STAFF RECOMMENDATION
3725 Princeton Avenue
June 20, 2012

Application: New construction—addition and accessory structure
District: Richland-West End Neighborhood Conservation Zoning Overlay
Council District: 24
Map and Parcel Number: 10409001100
Applicant: Mitch Hodge, Architect
Project Lead: Melissa Baldock, melissa.baldock@nashville.gov

Additions & Renovations to
3725 PRINCETON AVENUE
in the Historic Richland/ West End
Neighborhood of Nashville, TN

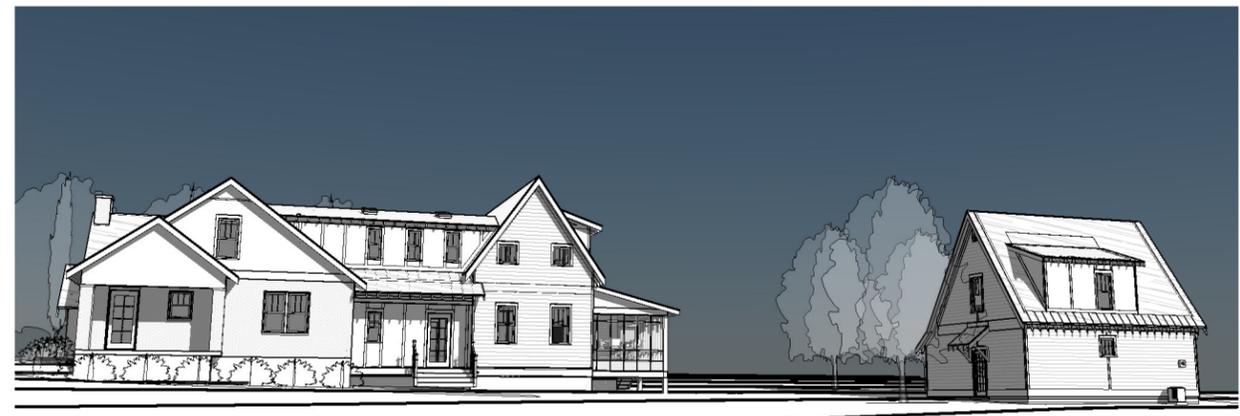
Applicant proposes to construct a two-story rear addition and a new two-story accessory structure. The rear addition will be taller than the existing house, and the project involves removing an existing rear dormer and covered porch (see photo below).

GARAGE

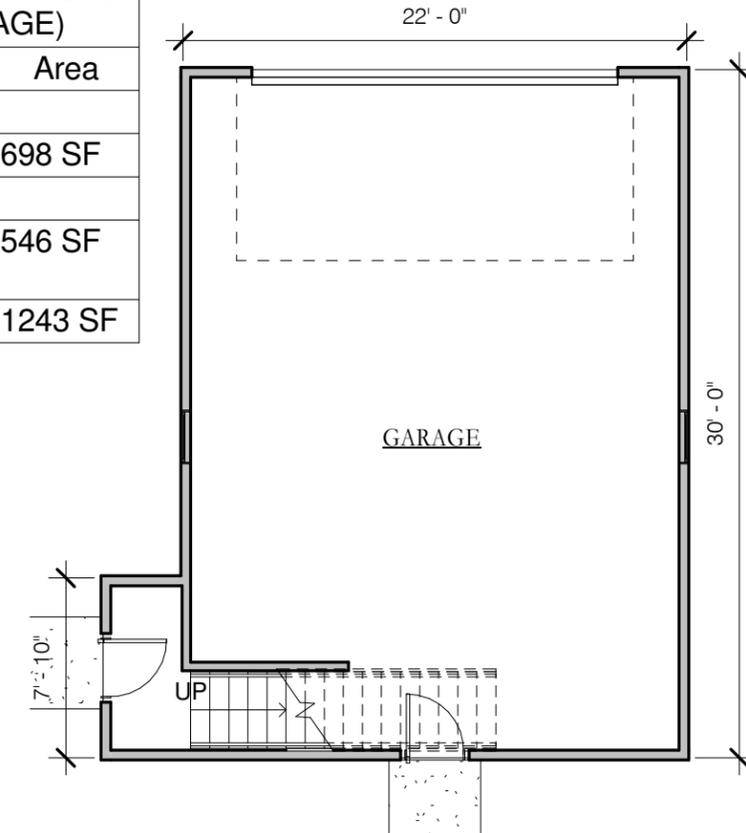
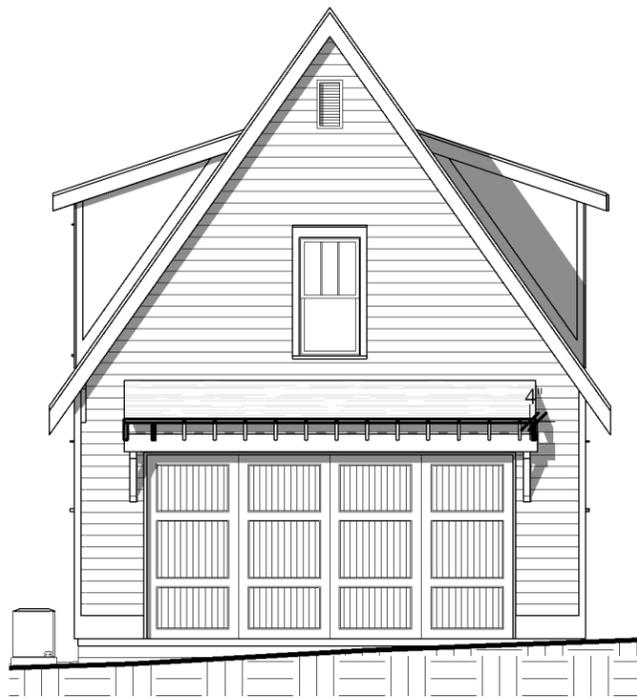
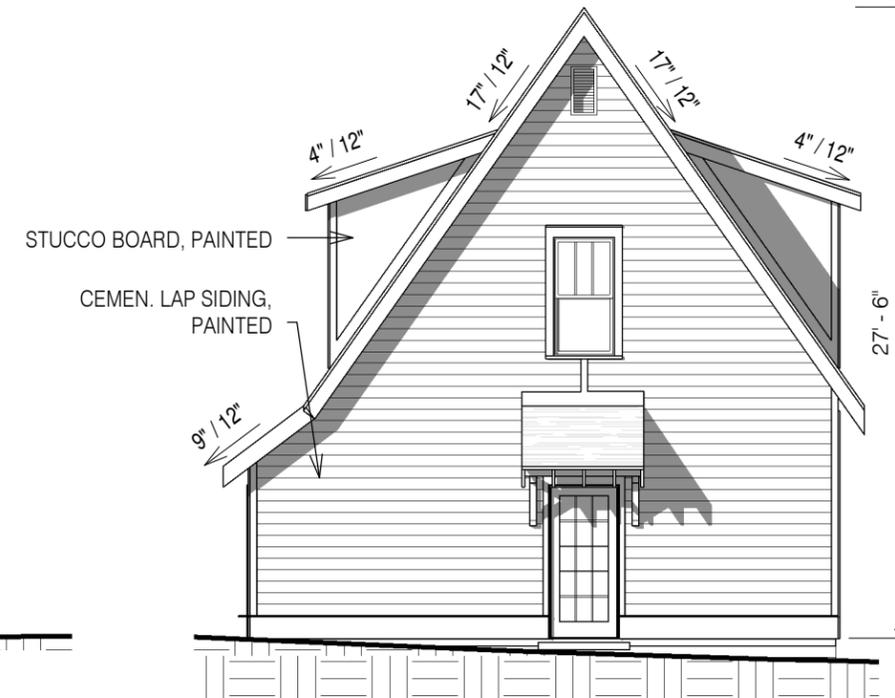
Outbuilding: The proposed accessory structure is located in the rear of the property, will be accessed via the alley, and will have garage doors facing the alley. The structure meets all base zoning requirements for accessory structures. It will be thirty-feet (30') deep and twenty-two feet (22') wide, with a three foot, six inch by seven foot, ten inch (3'6" X 7'10") entry area.

The accessory structure is proposed to be two stories and approximately twenty-eight feet (28') tall. Staff finds the proposed height of the structure to be problematic because it will be one-foot, four inches (1'4") taller than the historic house when the site's grade is taken into consideration. Comparing the heights of the two structures from grade to ridge, not accounting for slope, the accessory structure is five to six feet (5' – 6') taller than the historic house. Staff finds that the proposed height of the accessory structure does not meet the design guidelines because it is not subordinate to the historic structure. Staff recommends that the structure's height be reduced by a minimum of four feet (4') so that it is more than two feet (2') shorter than the height of the existing house when the site's slope is taken into consideration.

The accessory structure will have a side-gabled primary roof form with a slope of 17/12. While this slope matches the cross-gabled forms on the front façade of the historic house and is in theory appropriate, staff notes that the steep slope of the roof contributes to the accessory structure's height. Reducing the slope of the roof will reduce the height of the structure without reducing the structure's footprint. The structure's dormers will have shed roofs with a slope of 4/12, and the entry area will have a shed roof with a slope of 9/12. The accessory structure will be clad primarily in cement fiberboard siding. Its dormers will be clad in stucco board and batten. Staff asks to review and approve the accessory structure's roof material and color, and window and door materials and specifications prior to purchase and installation of these materials.

If the height of the structure is reduced by a minimum of four feet (4') and with the condition that staff approve the final materials, staff finds that the accessory structure meets section II.B.1.h. of the *Richland-West End Neighborhood Conservation District: Handbook and Design Guidelines*.

1. Staff review and approve the roof material and color; the window and door materials and specifications; and the materials for the addition's side and rear porch stairs and stair railings.
2. The accessory structure be reduced in height by a minimum of four feet (4').
